Attachment 1
NRC3-13-0015
(191 pages)

FSAR Markups

The following markup represents how DTE Electric intends to reflect this RAI response in the next submittal of the Fermi 3 COLA. However, the same COLA content may be impacted by responses to other COLA RAIs, other COLA changes, plant design changes, editorial or typographical corrections, etc. As a result, the final COLA content that appears in a future submittal may be different than presented here.

Figure 2.5.3-201 Map Showing Mapped Structures and Seismicity in the Site Vicinity

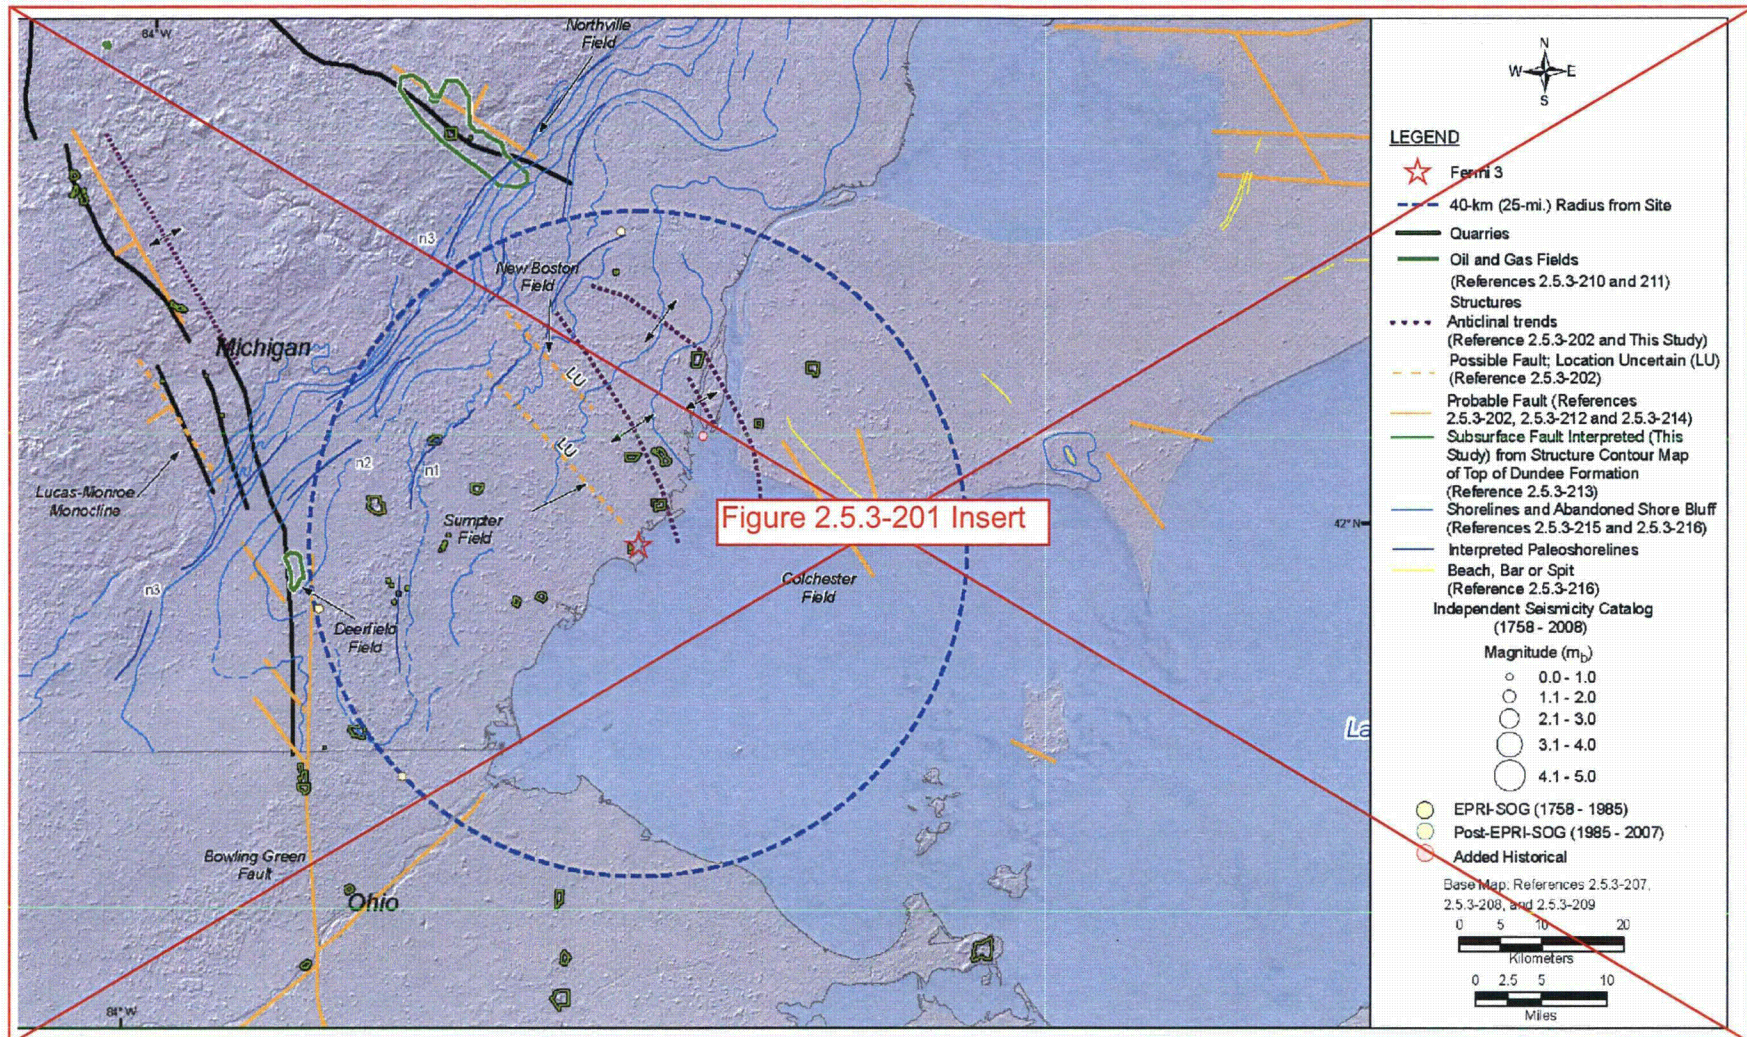
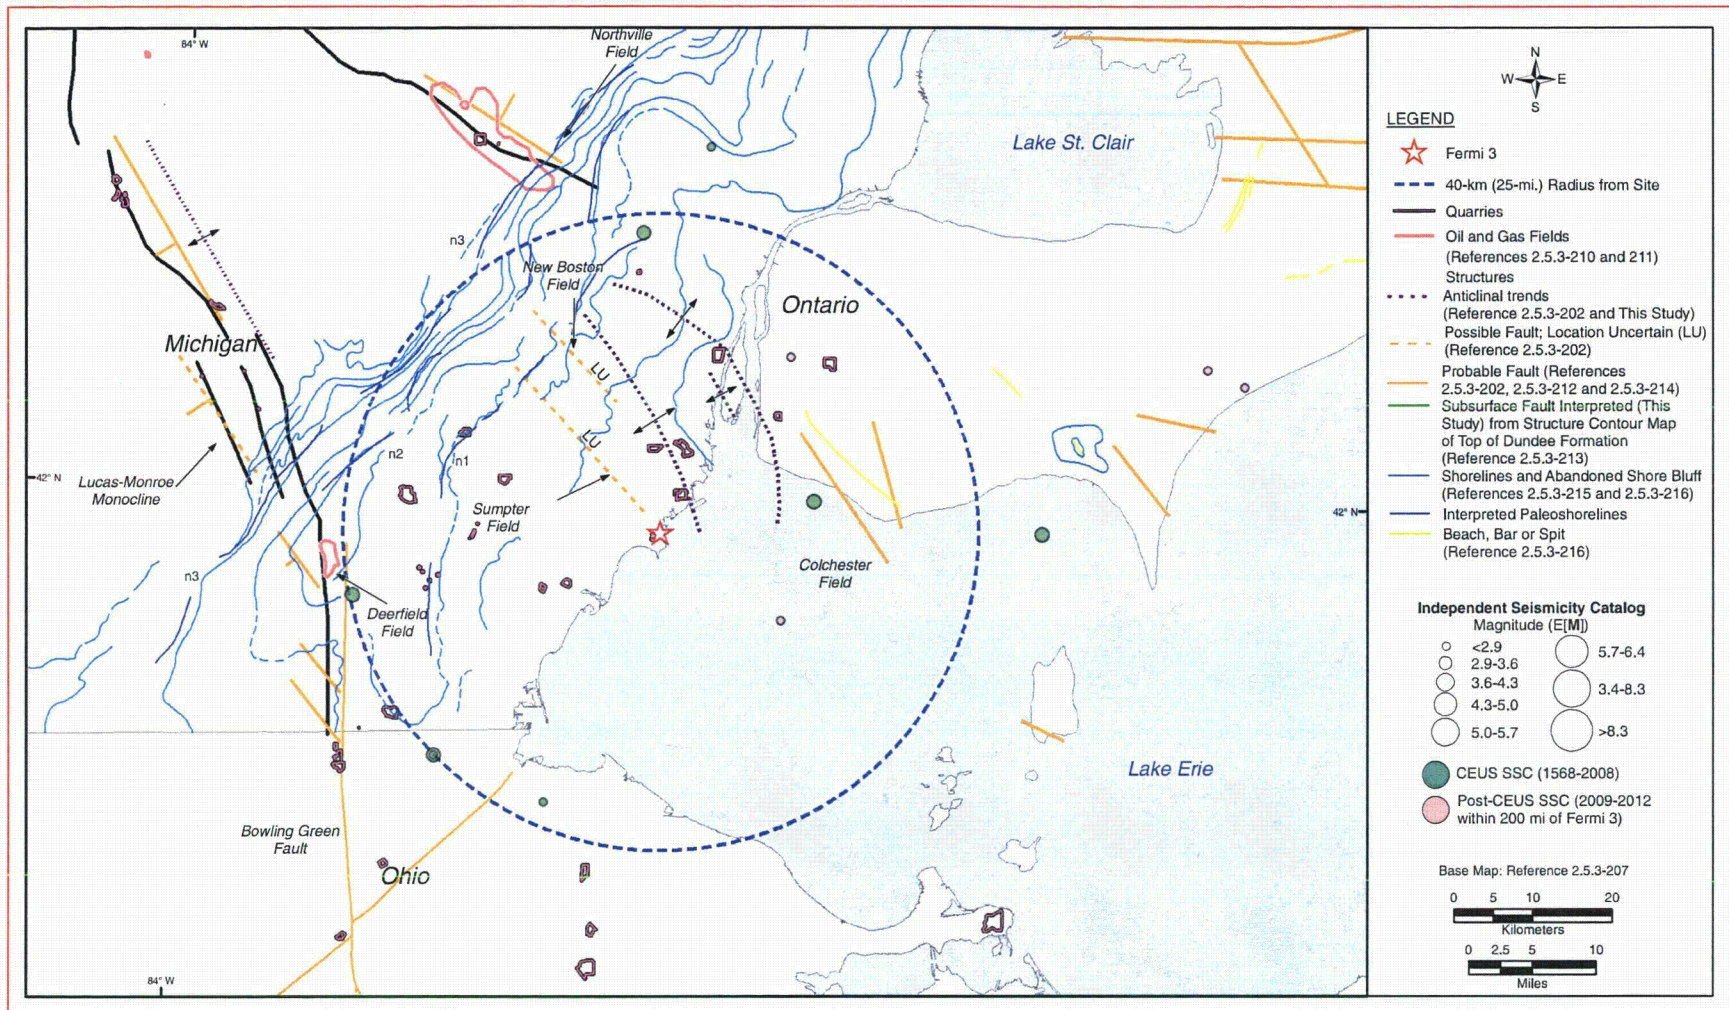
Figure 2.5.3-201 Insert
